INDESIT company

Model type:
AVSD1090SEXV

Commercial code:
F045740

n4008f00: Thermic link wire removed on three-phase motor

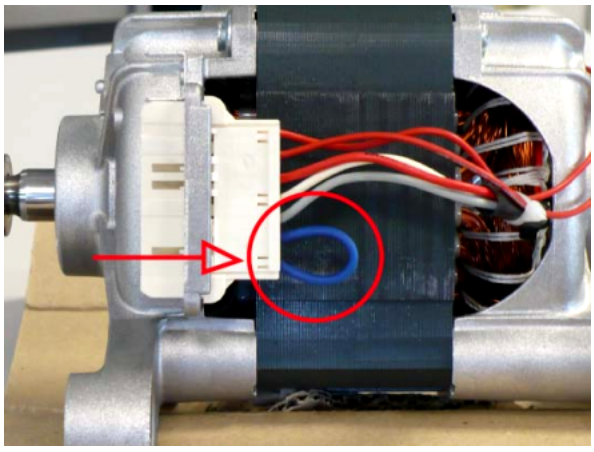
Attention!
When you assist the premodification models using the new motor code you MUST use the thermic link wire code C00265838.

The spare part warehouses will manage the premodification motor until the end of the stock, after they will be replaced with new ones and thermic link wire.

In the attached image you can see the fixing of thermic link wire in the motor therminal box.

TRIPHASE P40 46 L – INOX TUB
C00265827 new motor without thermic link wire - C00116103 premodification motor with thermic link wire

TRIPHASE P40 46 L – PLASTIC TUB
C00265826 new motor without thermic link wire - C00142390 premodification motor with thermic link wire

TRIPHASE P50 52 L
C00265829 new motor without thermic link wire - C00142205 premodification motor with thermic link wire

TRIPHASE P32 46 L TOP LOADING
C00265832 new motor without thermic link wire - C00262375 premodification motor with thermic link wire

TRIPHASE P40 46 L TOP LOADING
C00265834 nuovo new motor without thermic link wire - C00112739 premodification motor with thermic link wire
